Rev E to Rev F 3/8/78 Brian Rosen

XEROX EOD	Project D0	Control Board Change History	File D0csChanges.sit	Designer Rosen	Rev Gc	Date 7/18/80	Page 15
--------------	---------------	---------------------------------	-------------------------	-------------------	-----------	-----------------	------------

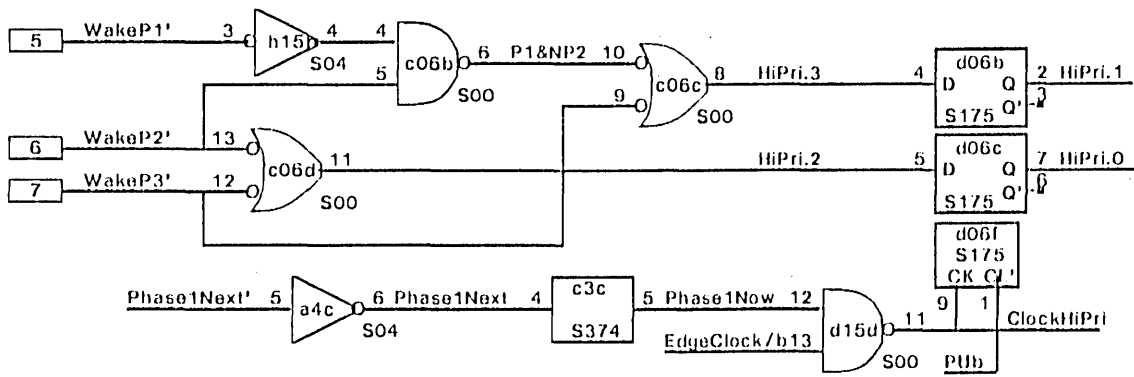
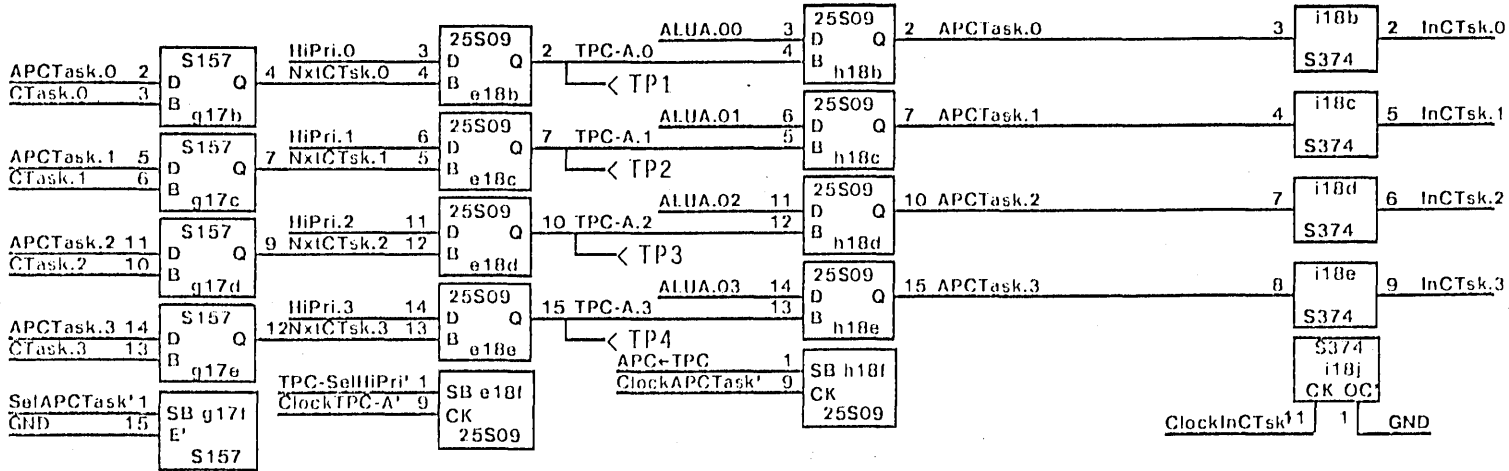
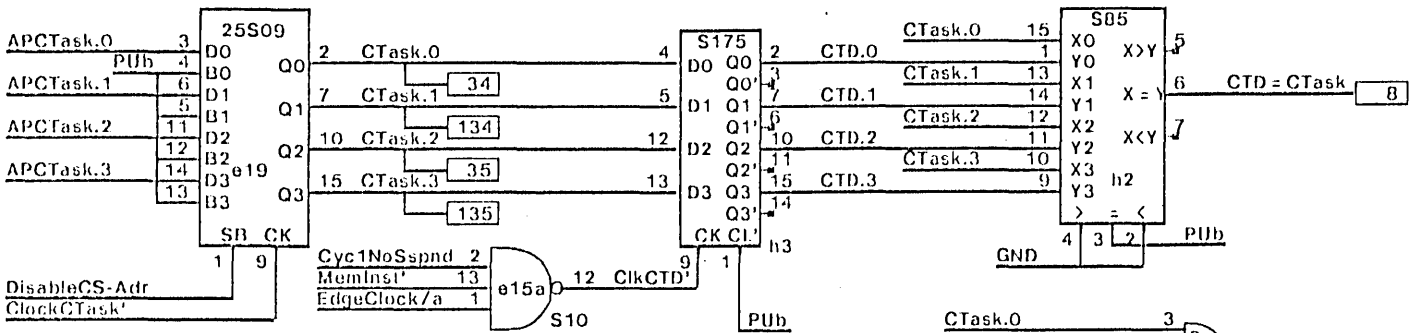
- 1) The Clock Drivers on page 12 were moved from c1/d1 to a18/b18 to eliminate waveform distortions due to reflections at the connector that caused false clocking on some boards. This necessitated moving the TPC-A multiplexer (page 1) from b18 to g17, and the Wake-up encoder S00 from a18 to c06. The wake-up lines now have long stubs on this board. The HiPri register was also moved up next to the S00 encoder (from e01 to d06).

- 2) The S30 at g6 that makes BPC-Rel' (page 10) had Breakpoint' added to it. This prevents the BPC-Refill trap from occurring when the successor of a breakpointed instruction points to an instruction which has NextInst or Nextop specified.

- 3) The trap location for Fault and BPC refill were reversed by changing the term on CS-A:11 from BPC-Refill' to StartFault' (S20 at a6 on page 9). Faults trap to 1, BPC refill traps to 0. This forces a nextinst/nextop which both BPC refills and Faults to hit the fault handler rather than the BCP handler.

- 4) The EPROM sockets were changed to allow 2716s or 2750s to be plugged in. This removes all dependency on the +12/-5 supplies for booting, and allows a 1k boot program. This change also affected the bit tested to determine end of boot load (from APC.00 to APC.05, thus affecting TstAPC.00 on page 3 and page 11)

- 5) A new Clock was added for the EOM board (ROS printer). This clock, EomClock, is a 35ns (nominal) squarewave, with a clock driver. See page 12.
- 6) Final testability changes were made, they include: a) A new signal, TesterDisable which is an independent pullup resistor on a new plat at e2 (page 11). This signal enables the S241 on page 3 which allows tester control of TstAPC.05, Enable BootProm, EnabCIA. b) another new signal, also an independent pullup (page 11) which allows tester to force CSOp to set. c) an S51 at b1 now lets the tester turn off the oscillator with a new signal-ExtClockEnab'. This signal is pulled up on the e3 plat instead of ExtClock'. c) the clock generator flip flops can be initialized by the InitClk' signal, which is pulled up on the e2 plat.

- 7) a minor improvement was achieved by eliminating the S32 at d6. Only one section was used (SRData, page 10) and an unused S32 section was available in the e16 S32. d6 is now empty

- 1) The chip enables for the TPC rams (control sections on pages 1 and 2) were run through an S241 controlled by DisableTester to allow tester control of APC inputs

- 2) The Run/a signal was run through another tester controlled S241 gate to allow tester control of the EPROMs (page 11)
- 3) The select input of the data in mux for bits 32:35 of the control store (page 8) was modified to run through another S241 gate to allow tester control of the data input to these 4 RAMs.

- 4) A new pull down resistor was added to the e2 plat (page 11) creating the signal TesterPullDown. This is the control input to the tester S241 (page 3)

- 5) The signal ChipSelect' (an input to all 2147 RAM chips, pages 4:8) was broken up into 3 separate nets, each fed from an S410 gate at i6 (page 3, nets CsChipSel'a, CsChipSel'b, and CsChipSel'c)

- 6) An adder, S283 was added between CIA and the TPC ram inputs (page 1) to make the return address CIA + 1 (carries propagate through 4 bits only). New chip is at c1.

- 7) The clock term for CTD (page 13) needed to have MemInst' as an input. Added a new gate (e15a) to make this term.

- 1) The Abort' term on ClockTPC-A' (g15.11) page 2 is erroneous, it was removed.
- 2) The Cycle1 term on RunningT2 came very late for some qualifier terms. It was changed to Cycle0Feed' thus cutting two gate delays

- 3) The Complement of the actual BranchBurp signal is needed for new clock driver scheme (see note 4 below). Added an inverter to BranchBurp using a4.3 and a4.4 creating BranchBurp'. The signal from b6.3 (page 9) had its name changed to BBurp'

- 4) Clock Drivers (page 12) were changed from S32s to S37s. This changed all inputs on a18, b18 and c5.
- 5) Cycle0Feed' is too late. The S37 that created this signal (page 12) was deleted. Cycle0Feed' now come from a5.8 this affected the name of the signal at b3.5 (was EarlyCycle1, now Cycle0Feed') This EarlyCycle0 is also used on a10 (page 9) and i2/g2 (page 13). The next revision (I) will remove some of these loads For now, they are all Cycle0Feed'

- 1) The register ByteCode is added (f2,d1,e1, pg13). This register holds ALUA[6:13]' for one cycle following NextInst, so that the bytecode can be written into TPC by the subsequent RETURN. This allows task switches between bytecodes.

- 2) The signal SRData (buffered H2.15) has been deleted. This requires a backplane change (pg 4,5,10).
- 3) The branch logic on pg 10 is changed to add IntPending (in place of Disp999), QWO, and a SpareBranch.

- 4) The signal NxtInNoTsk' is generated in c6a (pg2). This signal is true if a task switch will NOT occur in the RETURN following a NextInst. This signal determines the source of APC data during NextInst.

- 5) The signal NxtInstRTN' is generated in i7c (pg2). This signal will be asserted by all RETURNS following NextInsts, and will cause ByteCode + 1 rather than CIA + 1 to be written into TPC.

- 6) The function decoder on pg 10 is changed to bring out SpareF', and rename DispCnt' and DispClr' to be IncMPanel' and ClrMPanel'
- 7) The generation of RUN (pg11) is different. The feed signal from d4.6 is latched, RUN is generated on platform e2. (NOTE: e2 is changed to 18pins). PwrBoot' is generated in e16d.

- 8) CSOP (pg10) is clocked by clockT2' (used to be called ClkFault', pg 12).
- 9) EarlyCycle1 (pg 12) was added to reduce loading on Cycle0Feed'.
- 10) Clk1 is brought to the backplane (E12 -> E112) so that a delay can be inserted to reduce the width of RamClock.

- 11) a5.13 (pg 12) is connected to InitClk' rather than to PUa.
- 12) Stack overflow logic is added on pg 13.
- 13) NewInst (used to be an F) is generated on pg14.

- 14) Added TimeOut branch condition (pg10) and brought R-ParErr and CS-ParErr to the edge connector (pg 13).

- 1) Changed all plats to 20 pins on logic diagrams to cause ROUTE to do no trace cuts.
- 2) Added synchronizer on TimeOut (pg 10)
- 3) Changed DOOff' to E53, ClrMPanel' to E55 (pg 10).
- 4) Added spare IC's in positions f1, g1, h1, i1, h6.

- 1) Added g3b, d1c on pg 14. This change keeps NewInst from occurring when the first microinstruction of a bytecode is aborted.

Rev Gb to rev Gc (7/17/80 - CT) Eliminated signal PwrBoot', changed RFB register clocking (pg 11).
